## Proposal for an amendment to ECE/TRANS/WP.29/GRPE/2013/6

### Submitted by the chairman of the informal working group on Retrofit Emission Control devices (REC)

### 1. Test sequence for particulate reduction REC

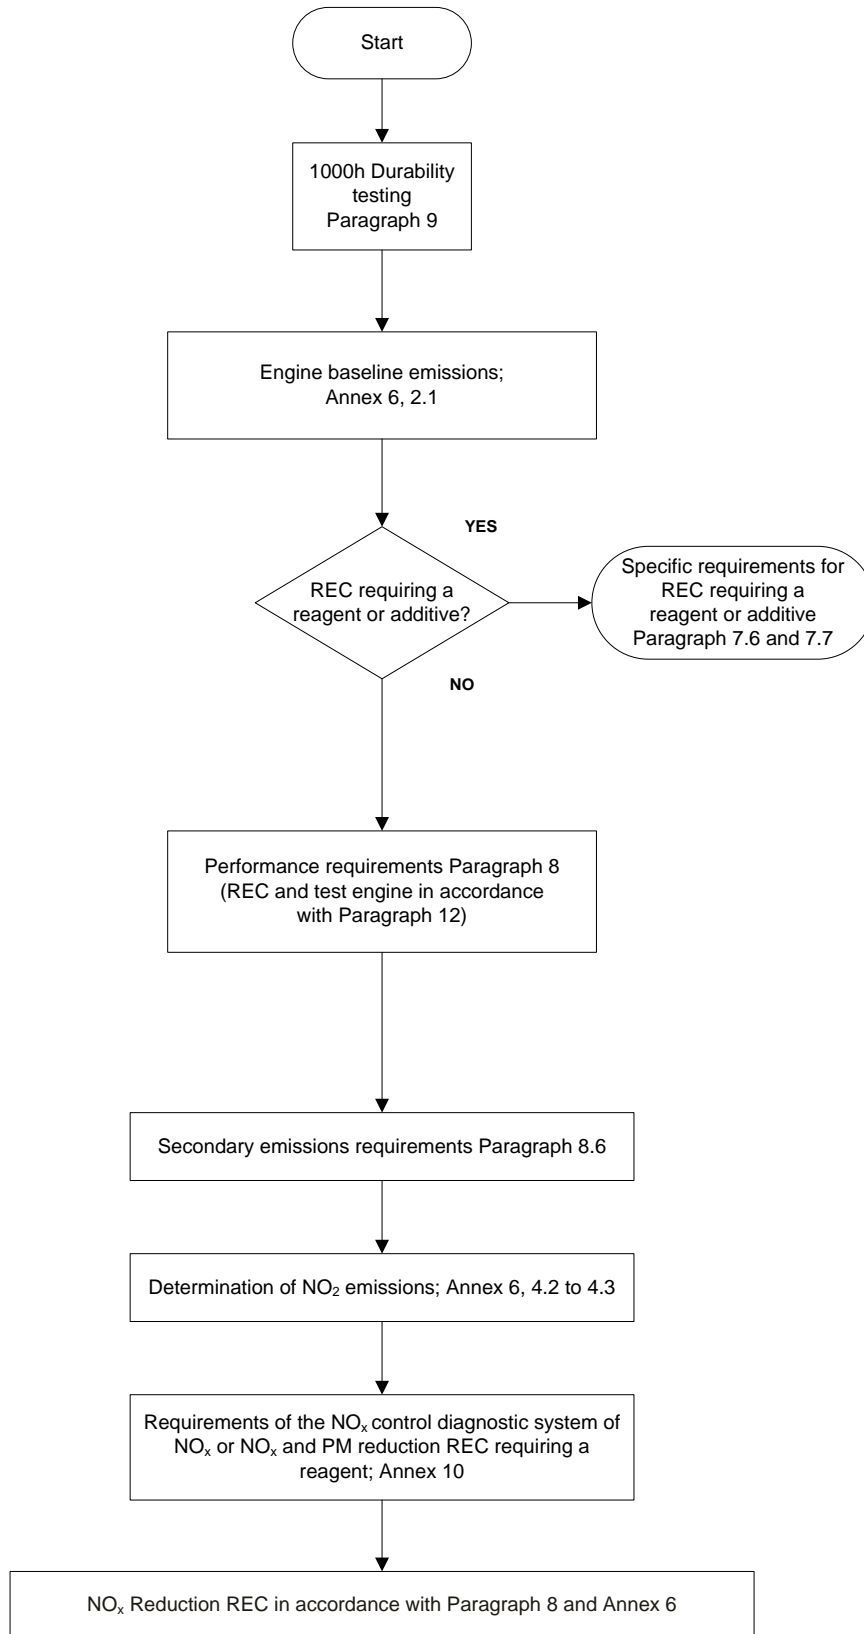
*Annex 8, amend to read:*
